CONTRACT NO. 1815

Miscellaneous Sewer Improvement 2025-2026

ADDENDUM NO. 3

ATTACHMENT D: DRAWING SET WITH UPDATED DETAILS ON SHEETS 11 & 12 (2 pages)

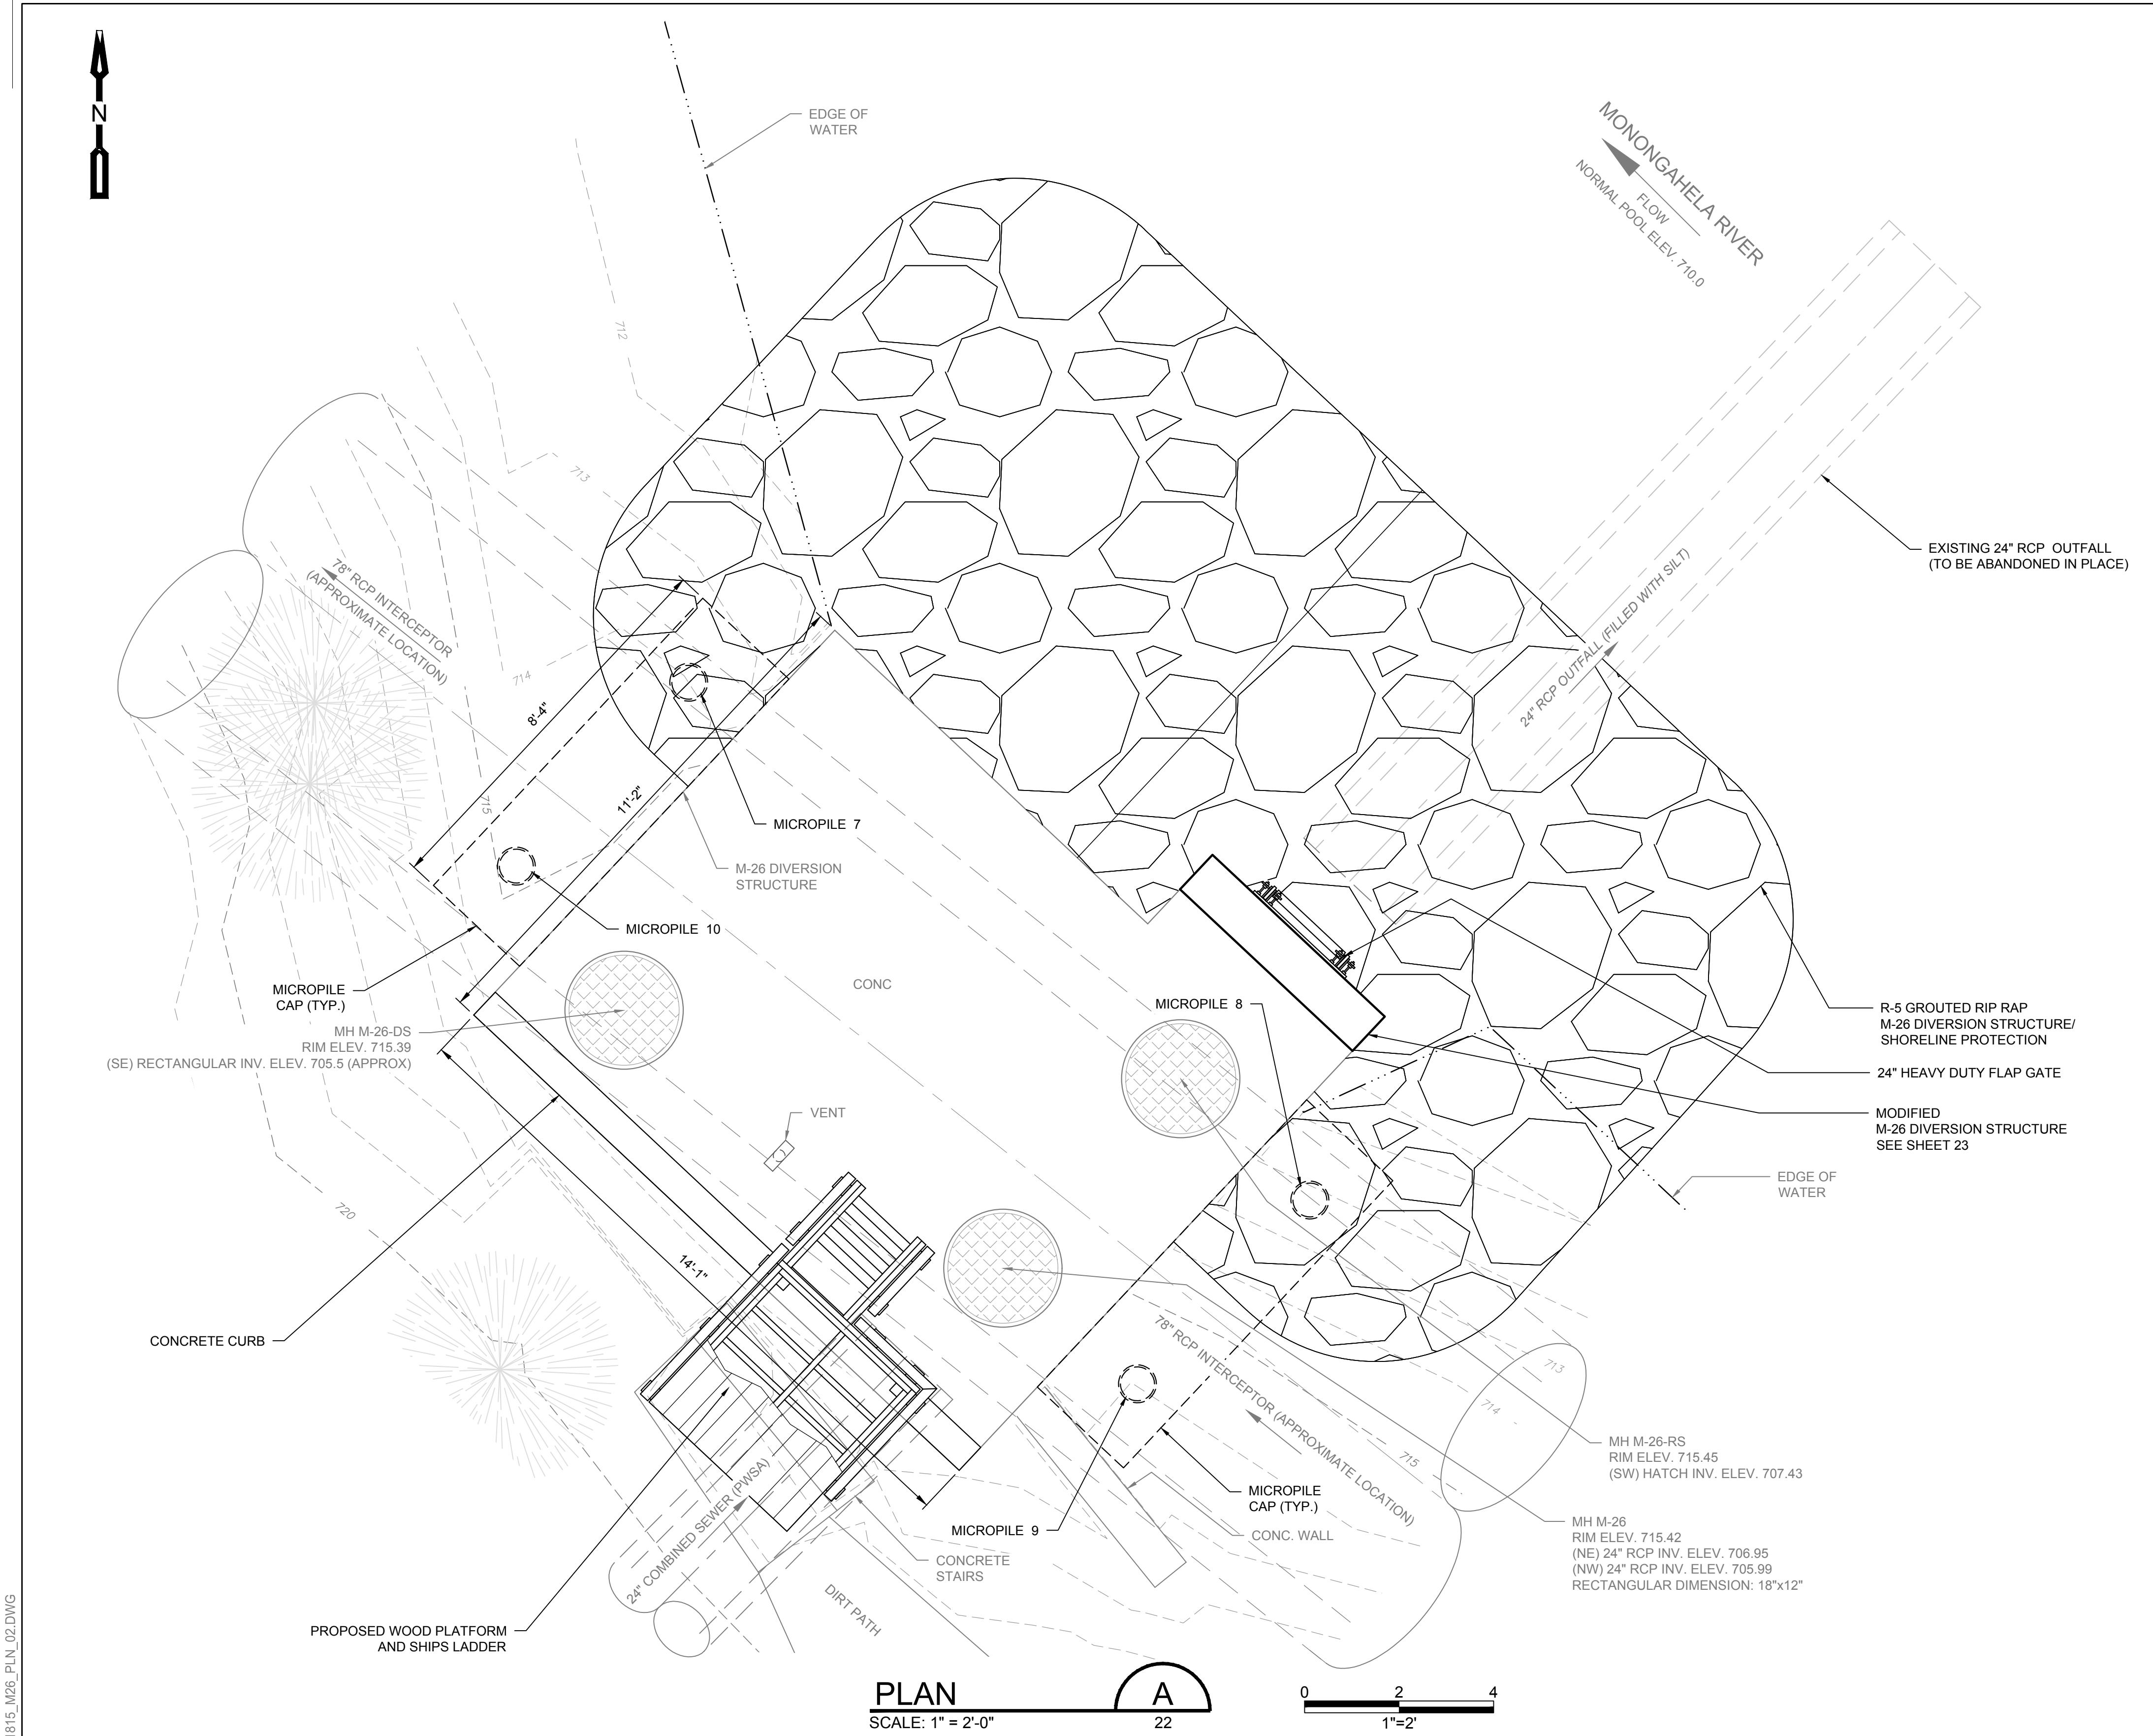
- 1.** The PennDot DM4 requirement noted in the specs affects the ultimate load and thereby leads to large sized micropiles. Please advise if this was the intended size for the micropiles.

Response: For micropile design purposes, lateral loads due to 500 psf construction surcharge and the lateral soil loads do not need to be considered concurrently. The designer shall consider the worst case of lateral load from construction surcharges and soil loads separately combined with other loads from appropriate loading (vertical dead, live and uplift loads). Also note allowable deflections are 0.5 inches at a single pile head and shall be calculated utilizing service level loads per specification 02466 Par 1.05 Art A.5. Notes will be added the micropile load schedules on Sheet 11 and 22 to clarify both of these points.

- B = LOADS DUE TO THE 100-YR FLOOD. (WSEL = 733.00) - FORCE IN TABLE DOES NOT SUBTRACT DEAD LOAD FROM UPLIFT FORCES.
- IT SHALL BE ASSUMED THAT LATERAL LOADING DUE TO CONSTRUCTION SURCHARGE LOADING (L) AND IN-SITU SOIL PRESSURE WILL NOT OCCUR SIMULTANEOUSLY. ACCORDINGLY, THE CONTRACTOR SHALL CONSIDER THE GREATER OF TWO LATERAL LOAD CONDITIONS TO PRODUCE THE WORST-CASE LATERAL DEFLECTION AND AXIAL/BENDING INTERACTION ON THE PILES DURING DESIGN USING THE APPROPRIATE LOAD COMBINATIONS.
